W-R-550A
AMENDMENT-1
August 18, 1977

FEDERAL SPECIFICATION

ROD, GROUND (WITH ATTACHMENTS)

This amendment, which forms a part of Federal Specification W-R-550A, dated June 12, 1975, was approved by the Commissioner, Federal Supply Service, General Services Administration, for the use of all Federal agencies.

FIGURE 2. Type II, Class A or B, driven rod.

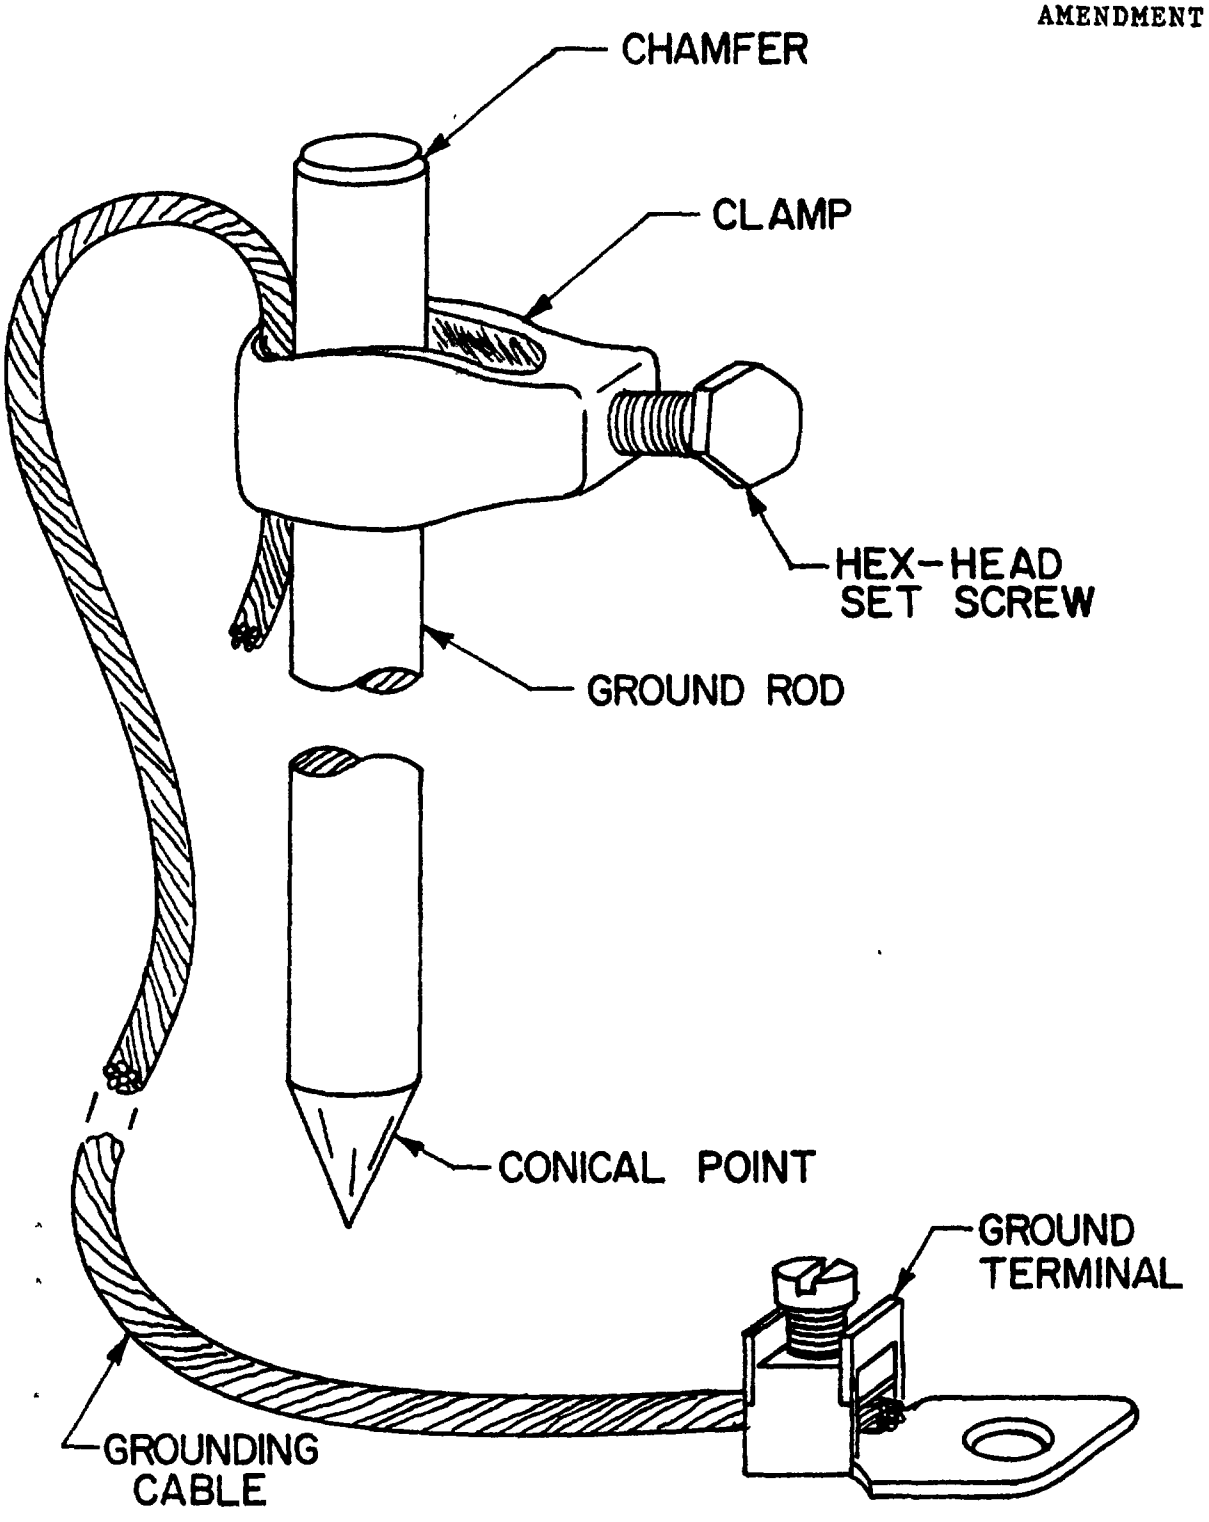
Figure 2, delete "SQUARE-HEAD" and substitute "HEX-HEAD"; show set screw as hex-head.

FIGURE 3. Type III, Class B, sectional rod. X-1883B

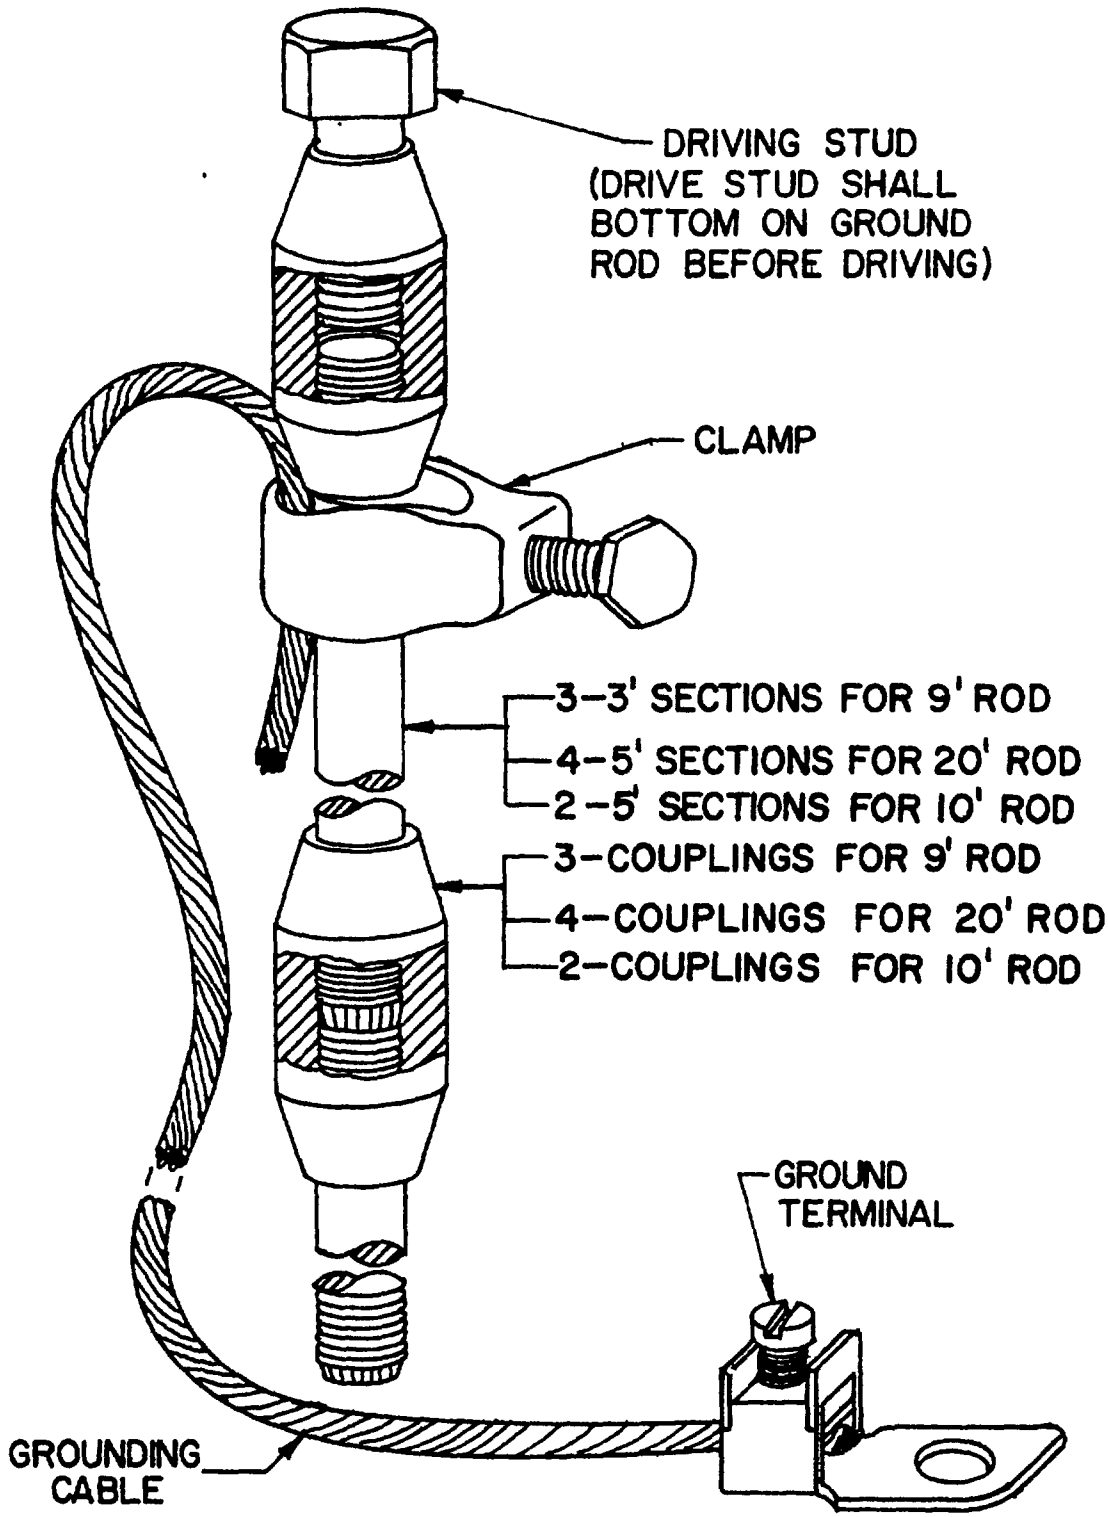
Figure 3, show set screw as hex-head; add: "2-5' sections for 10' rod"; add: "2-couplings for 10' rod".

FIGURE 5. Coupling for Type III, Class B, sectional rod.

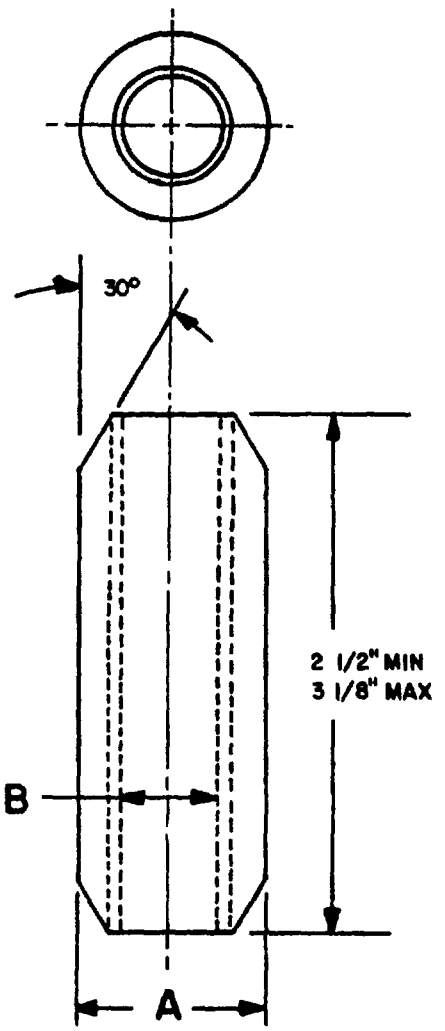
"3.3.1.1 Threads for the Type III, Class B rods and couplings. The Type III rods shall have 5/8-II-UNC-2A or 3/4-IO-UNC-2A threads as specified. The coupling shall be in accordance with Figure 5."

Add Figure 5.
